Duke Energy Ohio
Case No. 19-1471-EL-BLN
Staff Third Set of Data Requests
Date Received: April 2, 2020
STAFF-DR-03-002

Duke Energy Ohio
Case No. 19-1471-EL-BLN
Staff sECOND Set of Data Requests
Date Received: October 25, 2019
STAFF-DR-02-001

CONTACT/ ENGINEER:
JAKE DAWN

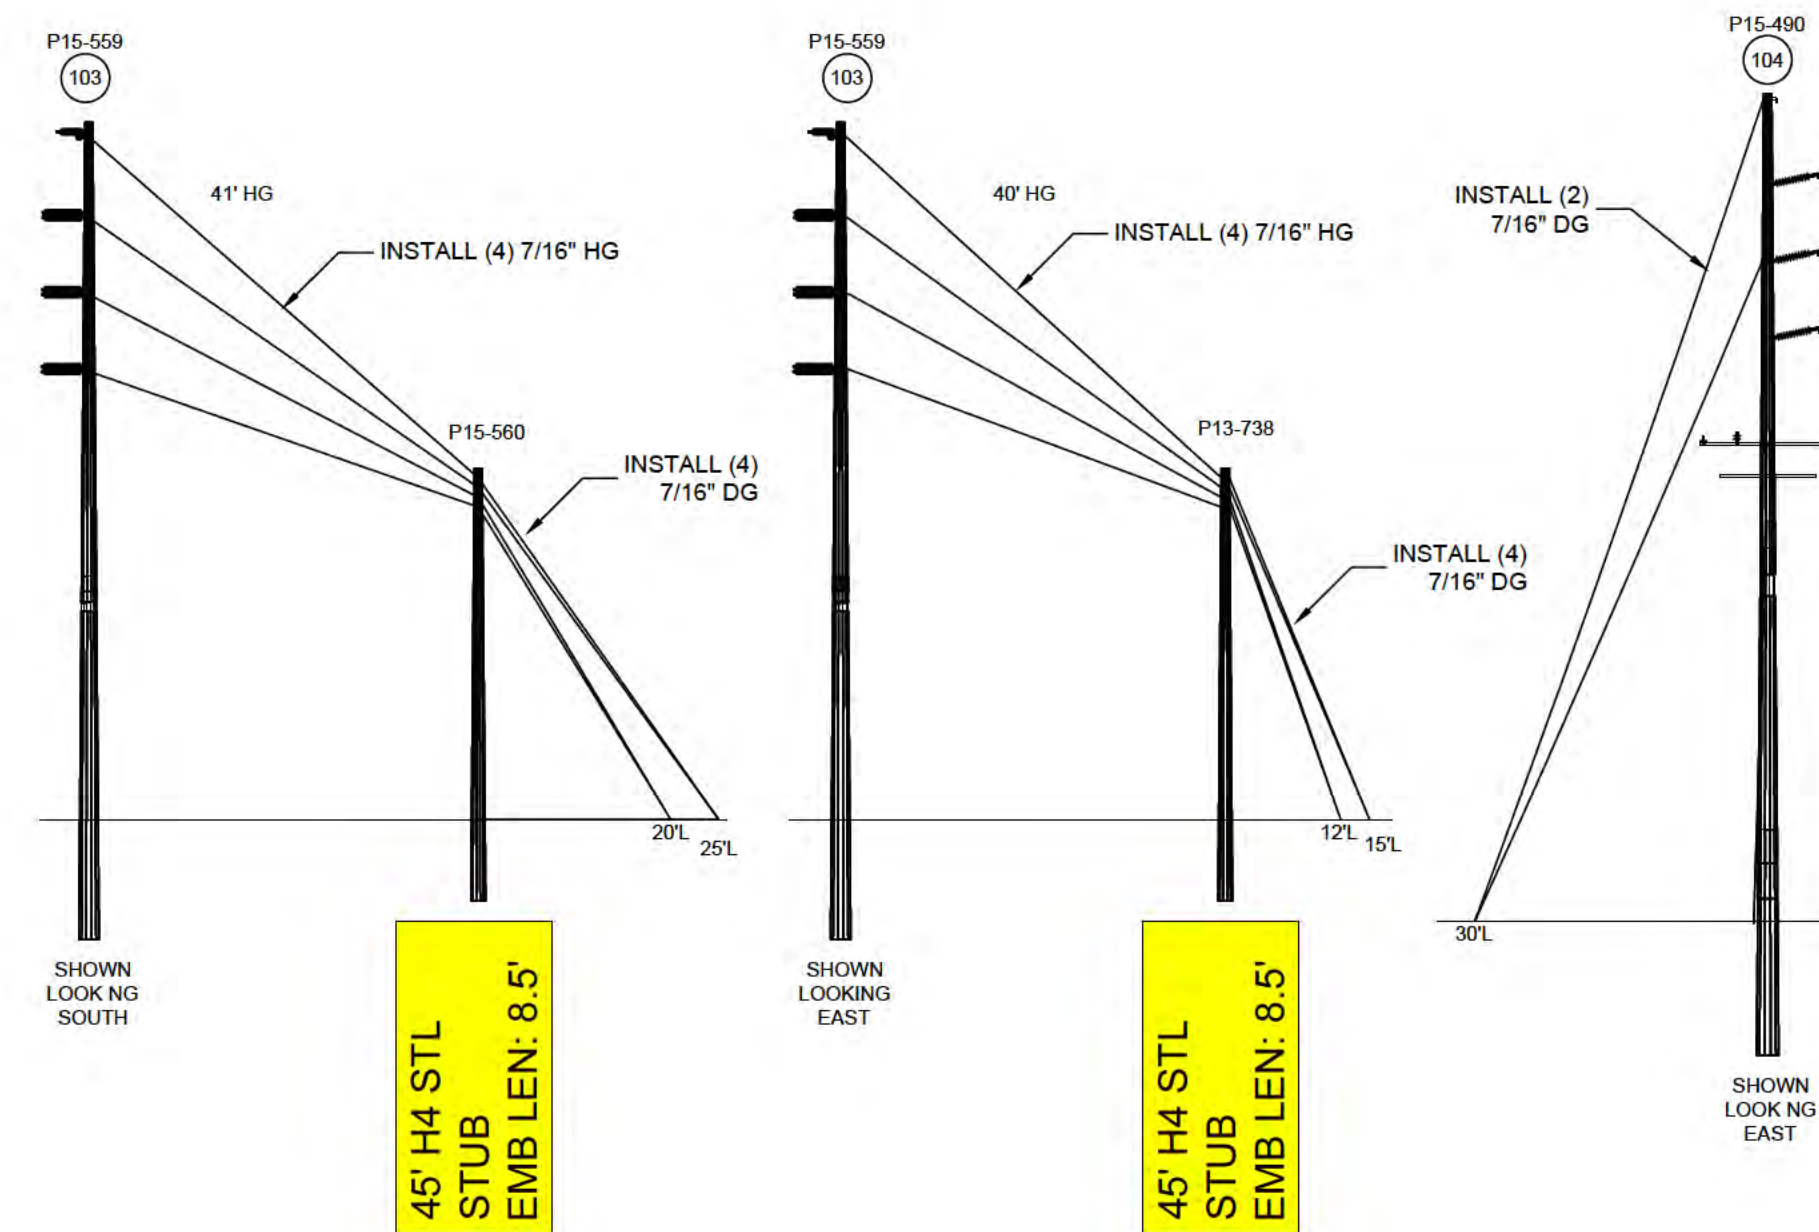
Please explain why the locations of the stub poles were not included in the original maps and shapefiles.

- a. Why are these structures necessary to construct the replacement line?

Please clarify the height of the new structures? The application states the heights of new structures ranges from 73 to 106 feet (46 total). Can you clarify this please, showing which height structures would be used in which locations?

Duke Energy Ohio did include the stub poles in its construction drawings. Please see STAFF-DR-02-001, including Attachments 1-4. This data request response was provided to Staff on October 29, 2019. A copy of that response is also being provided herewith, as Staff-DR-03-002 Attachment 1.

The Company has reviewed the comments and concerns about the stub poles being installed on the Elmwood Project. It has been determined that the stub pole locations were not shown in the maps that were part of the application, although they were shown in the Construction Drawings provided in STAFF-DR-02-001. Duke Energy Ohio's permitting team and engineers has determined that there was a loss of detail in the current method of extracting CAD files into the GIS environment in which the figures are developed. In future exhibits, the Company will extract CAD files using a different method into the GIS environment, in order to fully show the location of the structures (poles, stub poles, etc.).

- a. These structures are necessary to construct the replacement line because they support the guy wires.

Engineering drawings have been attached to show structure height.
